ILF CONSULTANTS, INC.
 400 112th Ave NE #205
 Bellevue WA 98004
 U.S.A.

LOWER CHURCHILL PROJECT
GENERAL REPORT – SITE INSPECTION OF DRAFT TUBE UNIT 1 FORMWORK AND FALSEWORK

The purpose of this report is to document deficiencies observed during a visual inspection performed on August 1, 2016. The inspection focused on the installed formwork and falsework in Draft Tube 1 elbow.

Figure 10: Butt joints not staggered (tower C1)

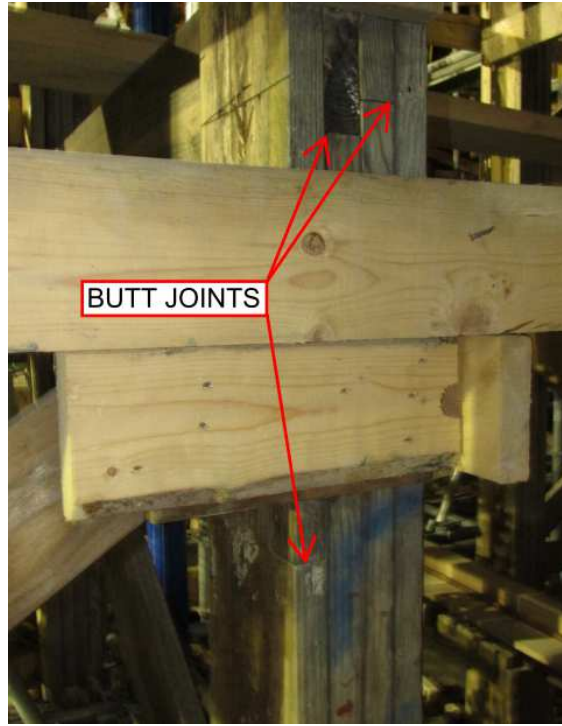
Butt joints in column members were not staggered as seen in Figure 10.

Figure 16: Uninstalled tower base anchors

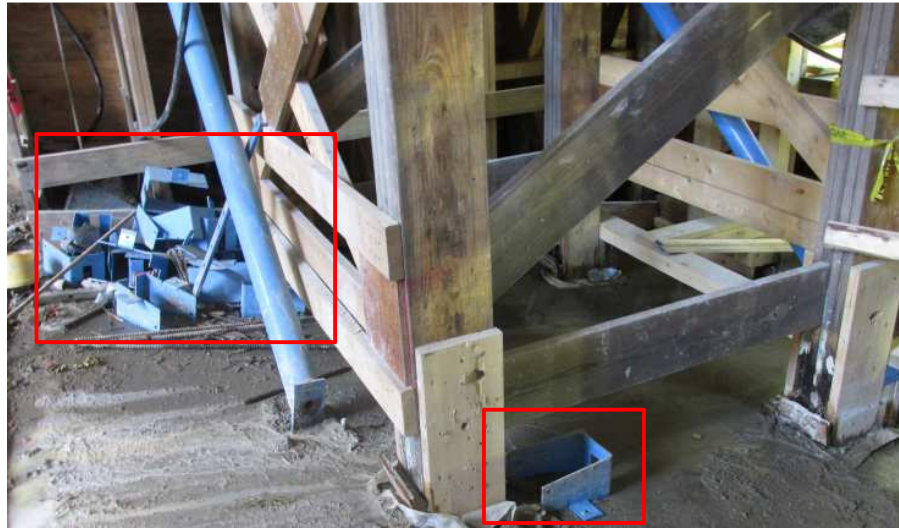
14 of the 16 shoring towers were not anchored to the concrete base slab as indicated on drawing MFA-AT-SD-3310-CS-D04-0066-01 to MFA-AT-SD-3310-CS-D04-0066-06. Figure 16 shows Tower A6 with no anchors installed and uninstalled anchors off to the side.

Figure 19: Incorrect size and installation of splice plate

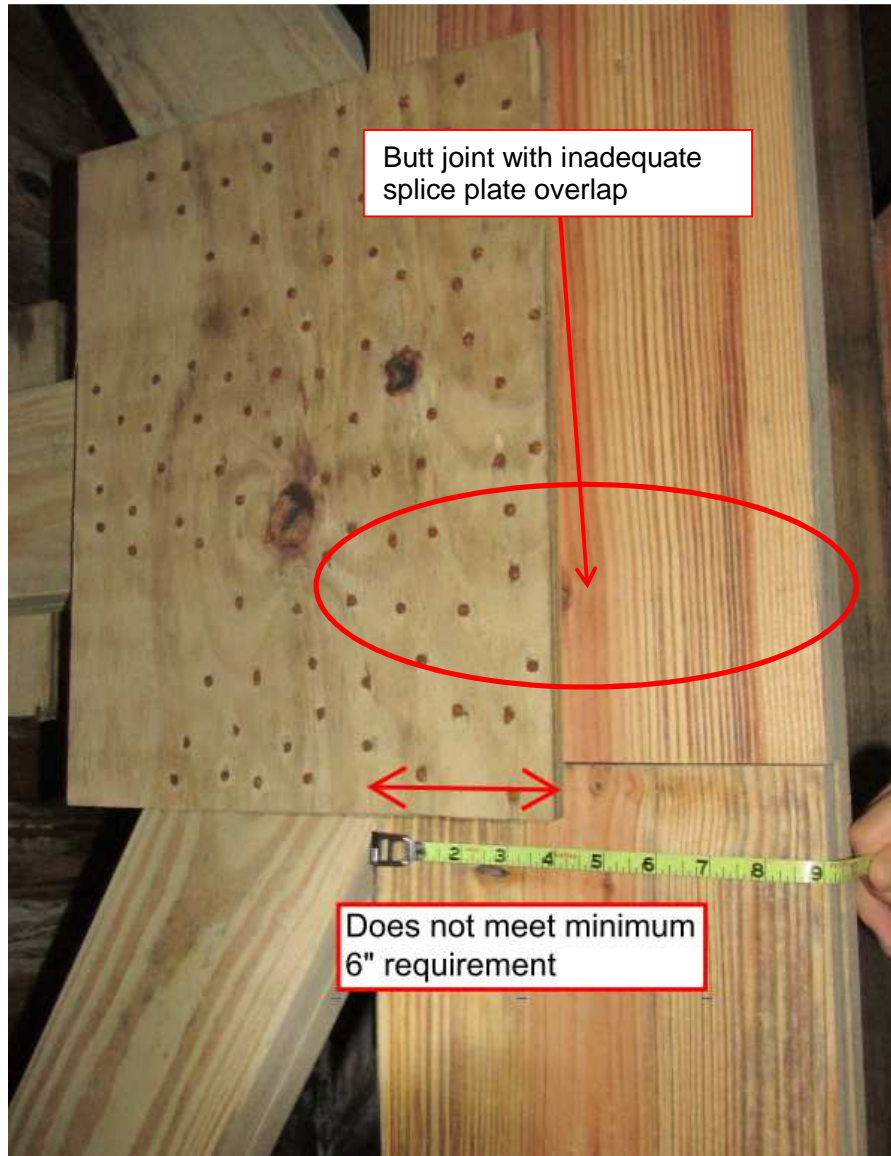
The observed deficiencies in Draft Tube 1 were primarily insufficient nailing and inadequate splice plates, as shown in Figure 18 and 19. OSB splice plates were not observed in Draft Tube 1. Signs of weathered wood and mold were also seen in the formwork panels (Figure 20). A summary of observed deficiencies in the formwork is found in Table 1.
